Re: Water Quality Certification for U.S. Army Corps of Engineers Public Notice 1996-4-02325 (Amended-1); Construction of a Third Runway and related projects at the Seattle-Tacoma International Airport (STIA) in the Miller, Walker, and Des Moines Creek watersheds and in wetlands at the Seattle-Tacoma International Airport, located within the vicinity of the city of SeaTac, King County, Washington; and in wetlands at the mitigation site in Auburn, King County, Washington.

ORDER #1996-4-02325 (Amended -1)

PROJECT: Port of Seattle Third Runway & Master Plan Update Projects

Attachment C
1996-4-02325
(Amended-1)
September 21, 2001
Wetland A17 Complex

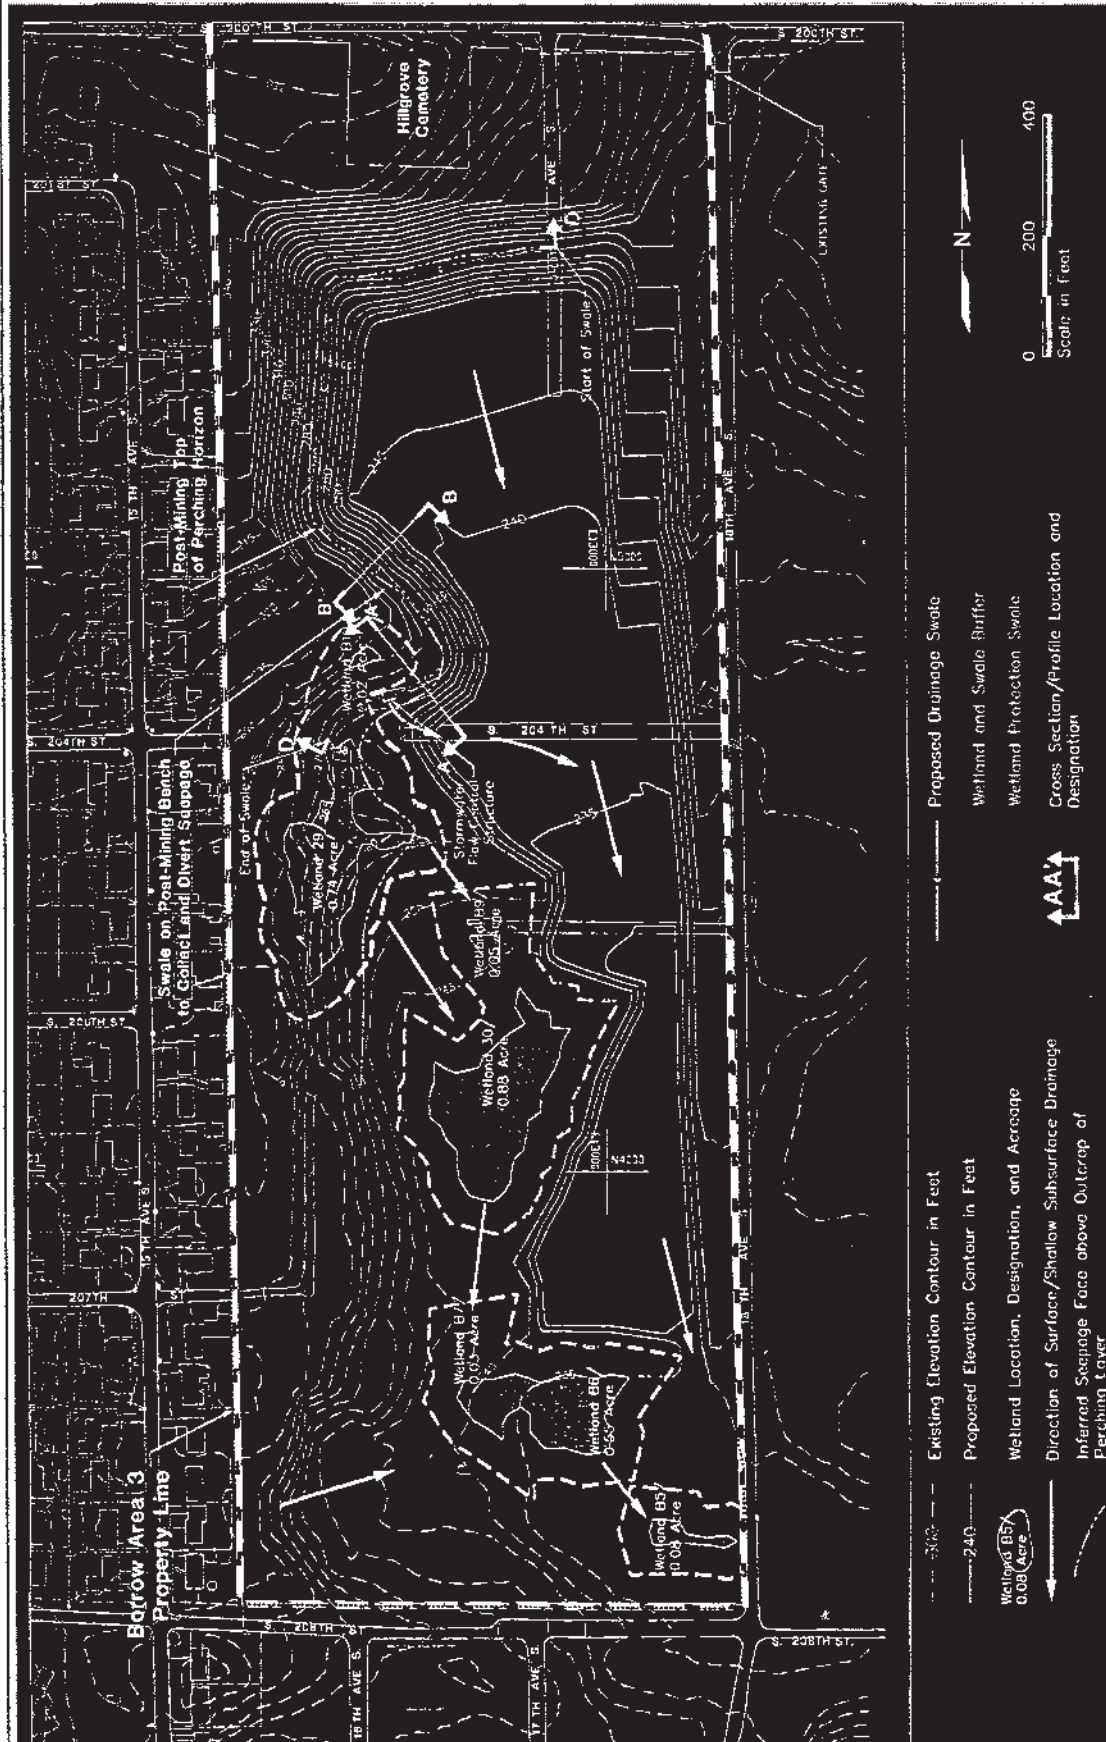
- a) The wetland/riparian zone comprised of Wetlands A17b/c/d (Wetland A17 Complex) and "Water D" shall be added to the wetland and buffer restoration/enhancement on Miller Creek. This area is depicted in **Attachment C** titled "Wetland A17 Complex". A 100-foot buffer shall be placed to envelop this system. Wetlands A17b/c/d comprise a total of 2.64 acres and "Water D" totals 0.16 acres for a combined total of 2.80 acres (not including the buffer). The buffer shall be averaged, similar to the buffer on Miller Creek. The buffer area may include location of the airport detection system (ADS) to the extent that its footprint has been minimized to the extent practicable.
